STAFF RECOMMENDATION
3807 Richland Avenue
November 19, 2018

Application: New Construction - Addition
District: Richland-West End Neighborhood Conservation Zoning Overlay
Council District: 18
Map and Parcel Number: 10409010100
Applicant: Brittney Mount, Allard Ward Architects
Project Lead: Paul Hoffman, paul.hoffman@nashville.gov

<p>Description of Project: The applicant proposes to construct a rear addition.</p> <p>Recommendation Summary: Staff recommends approval of the proposed addition with the following conditions:</p> <ol style="list-style-type: none">1. Where the addition is two-stories, it should sit in from the existing side walls by at least two feet, or at least the taller portion should sit in;2. Staff approve windows, doors, and roofing color; and,3. If relocated, the HVAC shall be located behind the house or on either side, beyond the mid-point of the house. <p>With these conditions, staff finds that the addition meets Section II.B of the design guidelines for the Richland-West End Neighborhood Conservation Zoning Overlay.</p>	<p>Attachments A: Maps and Photographs B: Site Plan D: Elevations</p>
---	---

Figure 2. The left side of the house and addition, noting the disparity in eave height

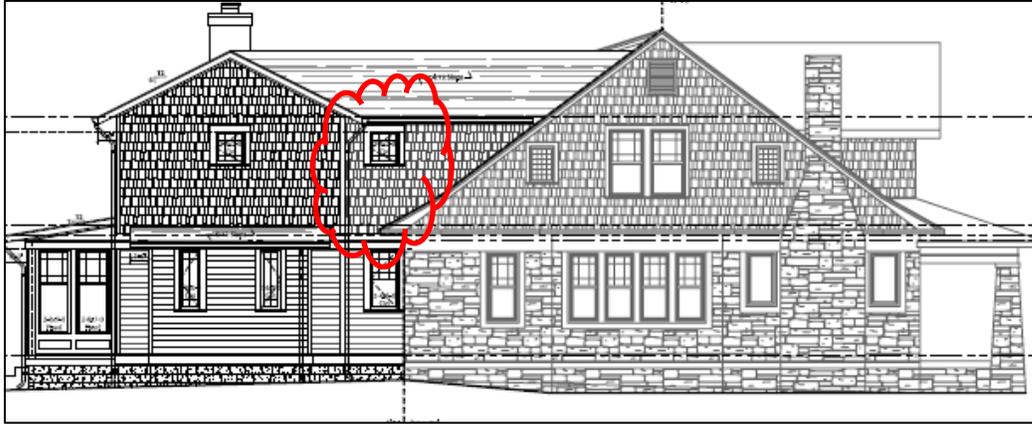
The ridge of the addition will be two feet (2') below the ridge of the house. The addition's eave height on the right side meets the existing eave height of twenty feet (20') from grade. On the left side, the eave height of the house is shorter at eleven feet (11'); however, where the addition widens after the inset to match the width of the house, the addition's eave height is nine feet (9') taller than existing.

The design guidelines state that the height of an addition's eaves should be subordinate to the eave height of the house. While it may be appropriate for a one story addition, if separated by an alcove or hyphen, to match the width of an historic house or to even be wider in limited situations, staff finds that the scale of the proposed addition is not appropriate because the eave height is taller, making the form of the addition appear larger and to have a greater number of stories than the historic house.

The Commission has required a two-foot (2') inset for two-story additions for many years for three reasons: to distinguish between the new and old, to make the addition easily removable if the original configurations are desired to be reconstructed at some point in the future, and to help hide additions behind historic homes. The Commission has also allowed for additions to step back out, after the inset, to meet the width of the house; however, when that addition is two stories and it is allowed to step back out behind a one-story or a one and a half-story home, the reason for the two foot (2') inset is no longer met.

Staff finds the scale of the second story is not subordinate to the original house. Staff recommends that either the full width of the addition maintain a two foot (2') inset or at least the second story is reduced in order to sit two feet (2') inside the silhouette of the historic house to meet sections II.B.1.a and II.B.1.b of the design guidelines

1. Where the addition is two-stories, it should sit in from the existing side walls by at least two feet, or at least the taller portion should sit in;
2. Staff shall review and approve windows, doors and roofing color; and,
3. If relocated, the HVAC shall be located behind the house or on either side, beyond the mid-point of the house.

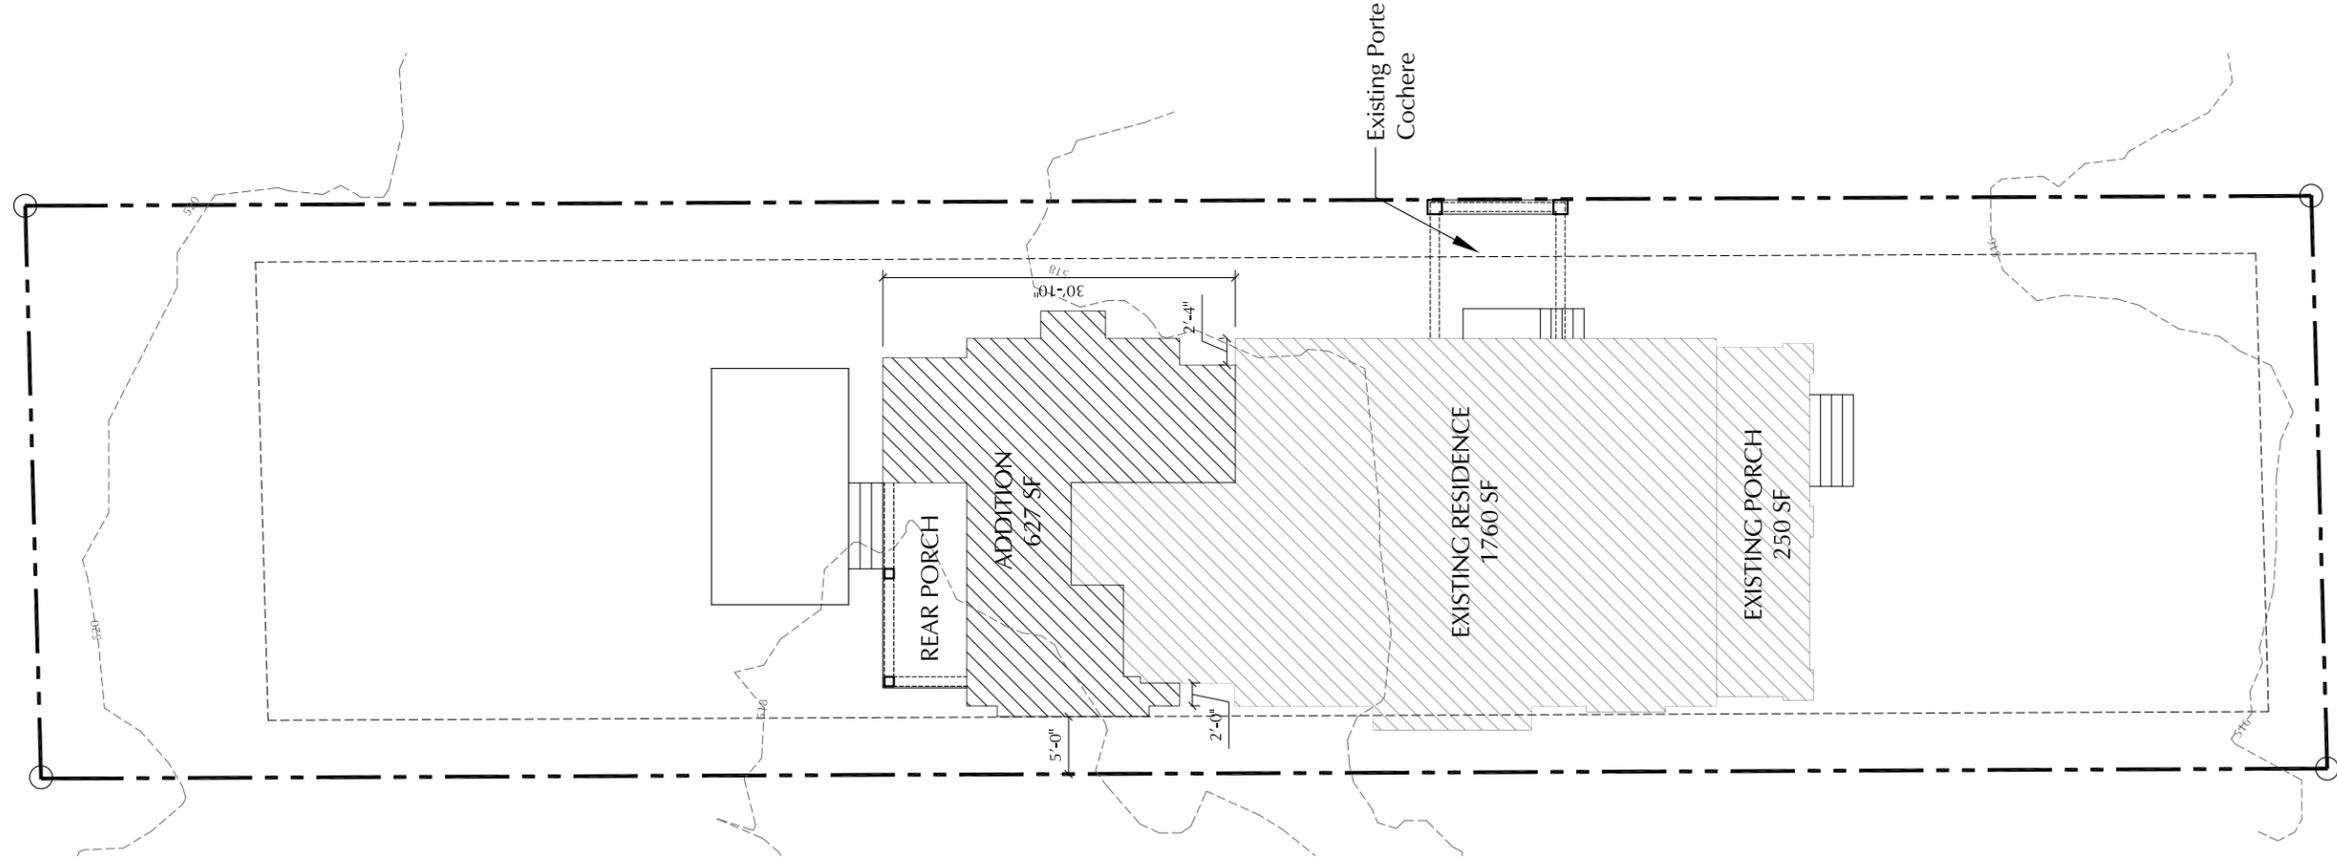
Proportion and Rhythm of Openings: The windows on the addition are generally twice as tall as they are wide. The left side of the addition includes two square windows; staff finds that the square windows are appropriate since they are located on the new construction in a less visible location. There are no large expanses of wall space without

a window or door opening. Staff finds the project's proportion and rhythm of openings to meet Section II.B.1.g of the design guidelines.

Site Plan

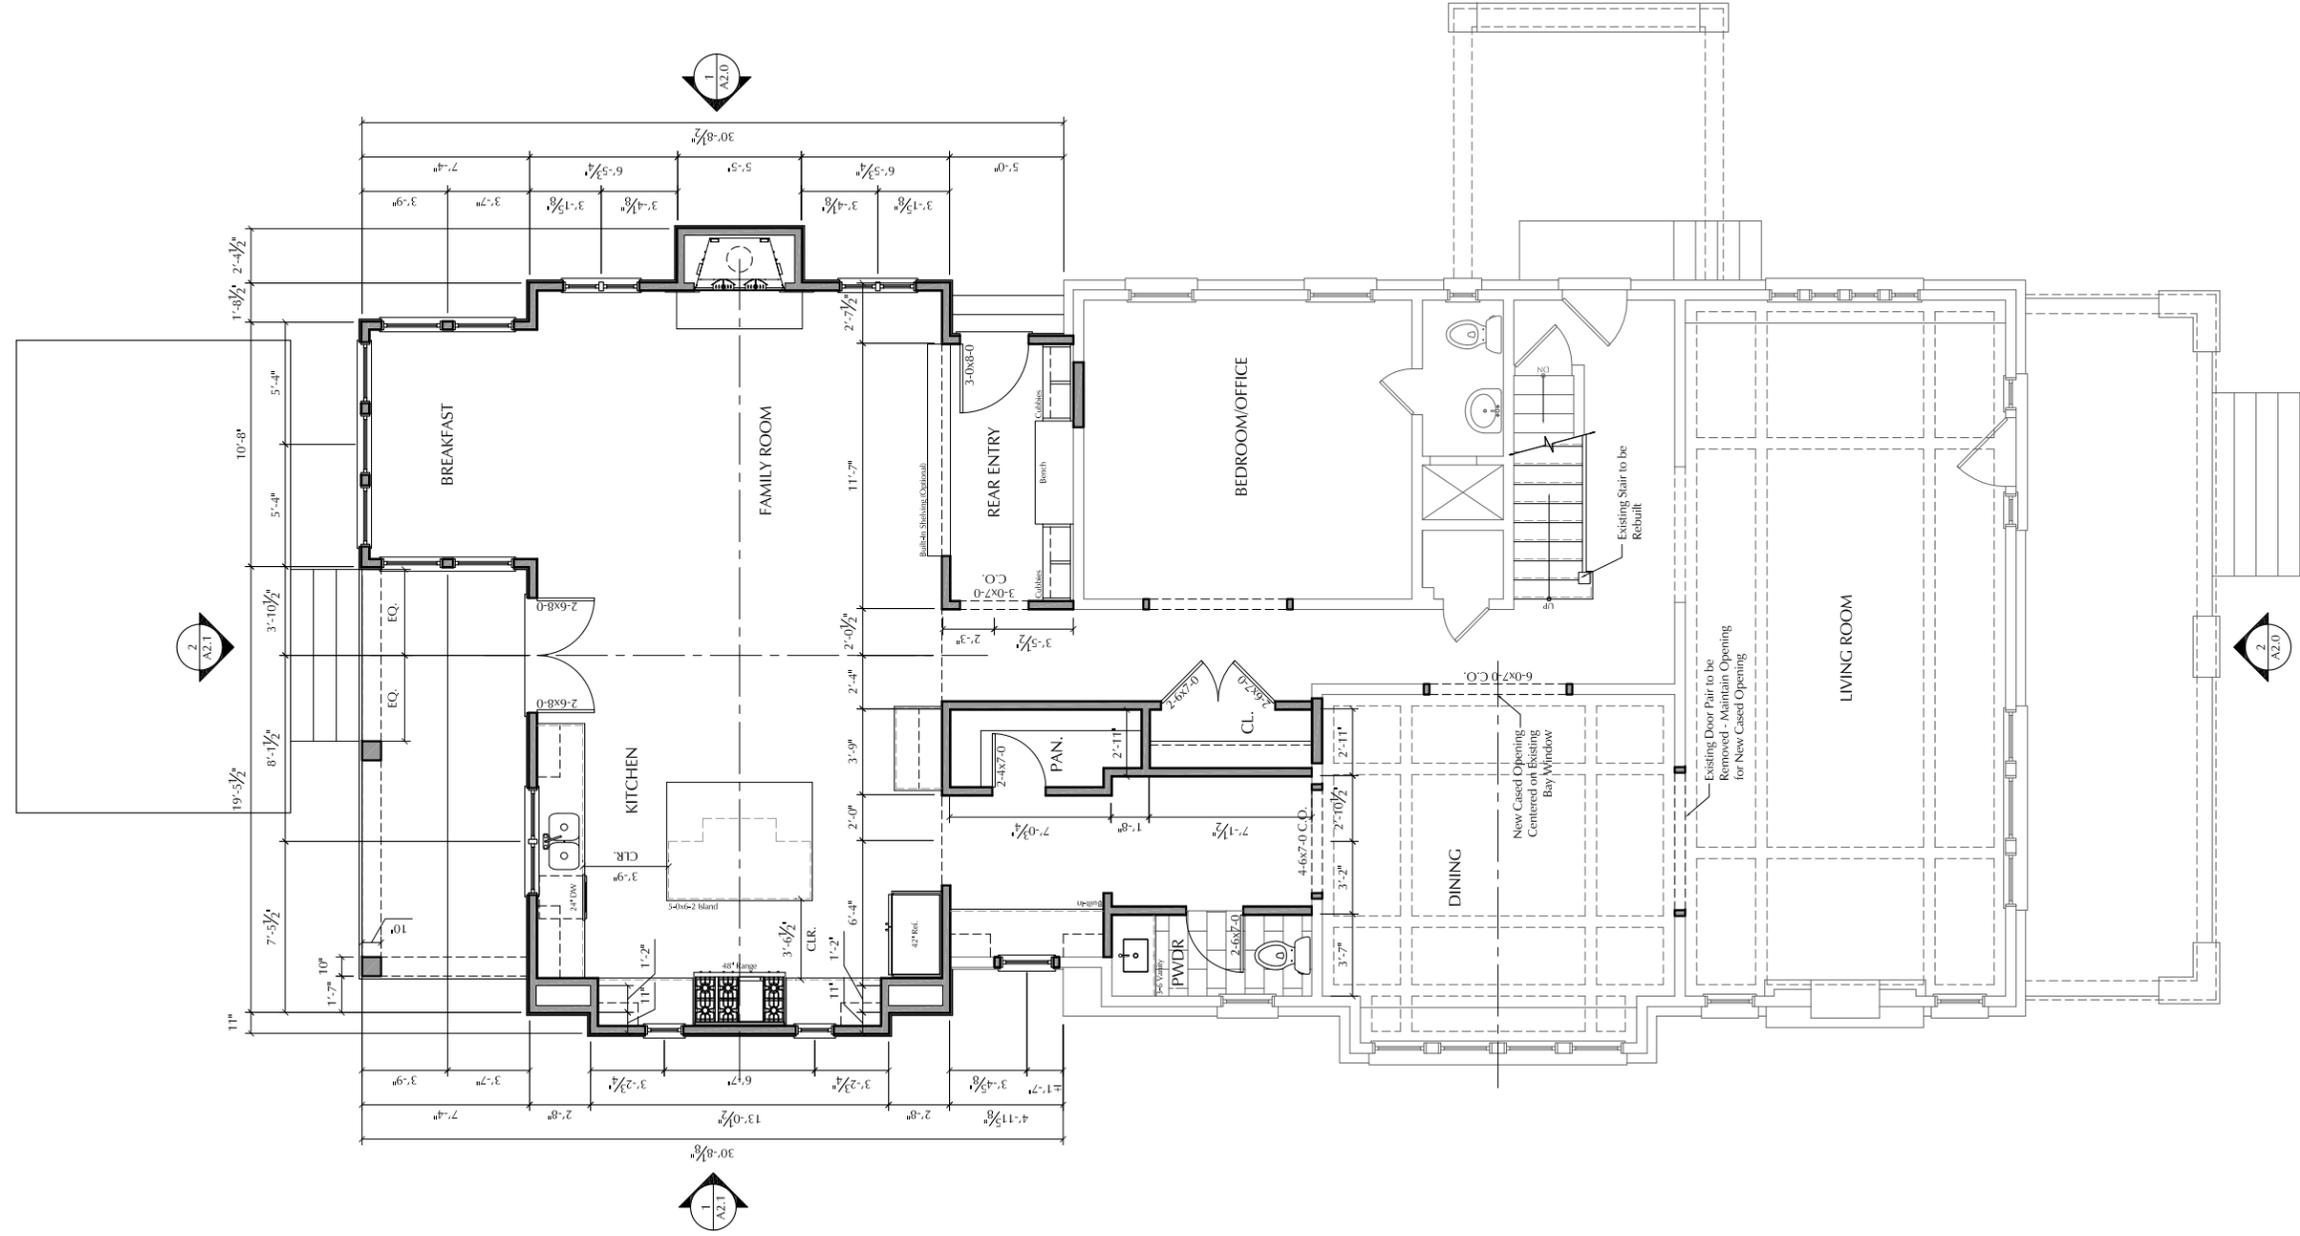
Setback & Rhythm of Spacing: The addition will be five feet (5') and nine feet (9') from the left and right sides, respectively, and will be approximately seventy-two feet (72') from the rear property line. The addition meets base setback requirements of five feet (5') on the sides and twenty feet (20') at the rear. Staff finds that the addition meets Section II.B.1.c of the design guidelines.
